# I-10 LAKE CHARLES CALCASIEU RIVER BRIDGE

## Final Environmental Impact Statement

### I-10 Calcasieu River Bridge Improvements

State Project Number: H.003931

Figure 58b- FIRM Map 22019C0480F, effective on 2/18/2011

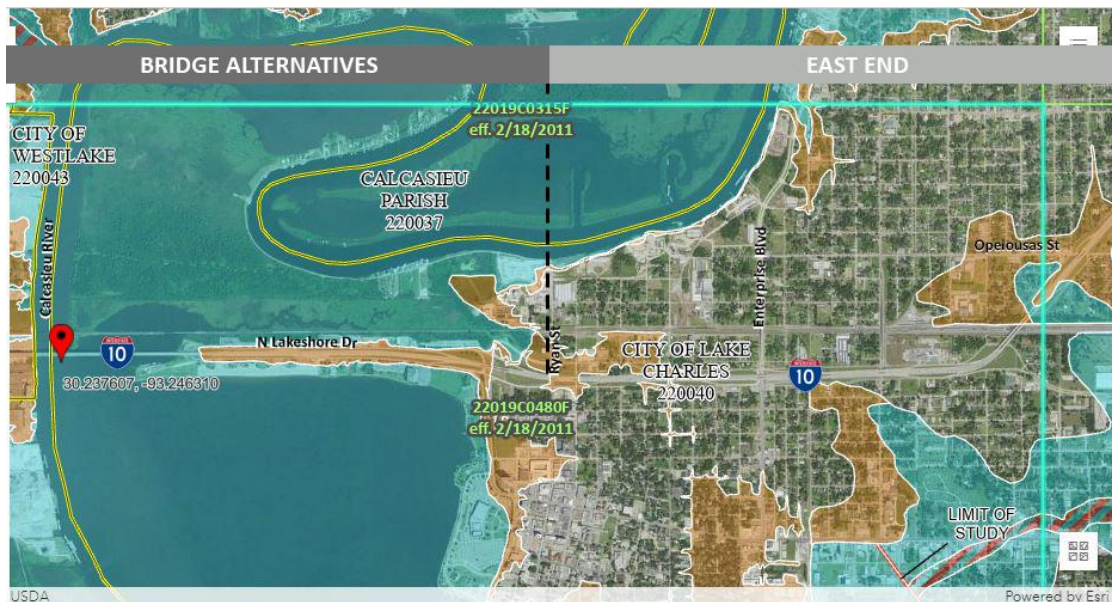
21. Figure 58, Flood Hazard Area, has been revised.

**Figure 58b** illustrates the base floodplain on the east side of the Calcasieu River which includes the Bridge Alternatives area of the Project and East End Improvements.

**Figure 58b** illustrates that the BFE for the base floodplain in this area is nine (9) feet. The elevation of the at-grade portions of alignment of I-10 in this area is proposed to be approximately 16 feet or seven (7) feet above the BFE. The elevation of North Lakeshore Drive would be approximately 15 feet (see Appendix H, Alternative 5G, Sheet 1 of 2, Vertical Profile).

The area shown on **Figure 58b** is surrounded by water bodies including the lake (Lake Charles) to the south, the Calcasieu River to the west, and a large, forested wetland to the north. The UPRR could impede flow into the north wetland. But conveyances to the west and to the south would be constructed to maintain flow through and around the encroachment of I-10 and North Lakeshore Drive to the lake and to the Calcasieu River. Covering approximately two square miles, the lake is connected to the Calcasieu Ship Channel and other waterways that flow to the Gulf of Mexico.

The area in the base floodplain (N Lakeshore Dr in **Figure 58b**) is currently developed as a highway commercial strip. This development will be displaced. The natural and beneficial floodplain values such as habitat for fish and other animals, protection of water quality, and recharge of groundwater have been impacted by industrial and commercial development but still provide benefits. The beneficial floodplain values of flood storage and conveyance would continue to function.

Figure 58c- FIRM Maps 22019C0480F and 22019C0485F, effective on 2/18/2011

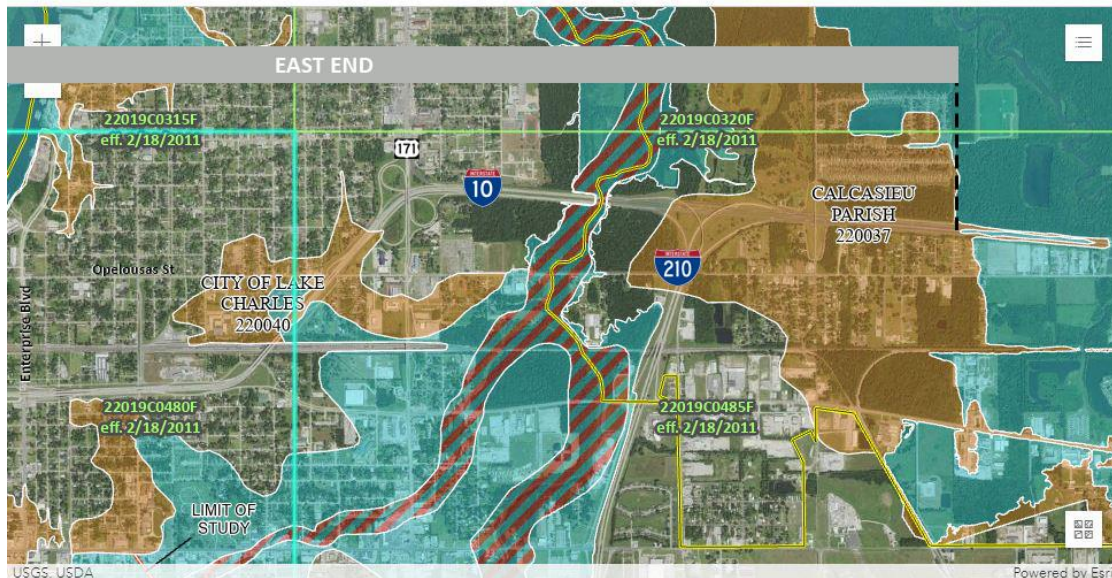
Encroachments exist upon the floodplain at the US 90 Bridge over I-10 on the West End of the project corridor (**Figure 58a**) and upon the floodplain on the East End where the Kayouche Coulee crosses under I-10 (**Figure 58c**). This waterway is identified by FEMA as a regulatory floodway, which is defined in 23 CFR §650.105 as a floodplain area that is reserved in an open manner, i.e., unconfined or unobstructed either horizontally or vertically, in order to provide for the discharge of the base flood so that the cumulative increase in water surface elevation is no more than a designated amount (not to exceed one foot as established FEMA) for administering the NFIP.

**Figure 58c** shows the base floodplain relative to the East End limits of the project and the Kayouche Coulee, a designated regulatory floodway in the floodplain (hatched area) which crosses existing I-10.
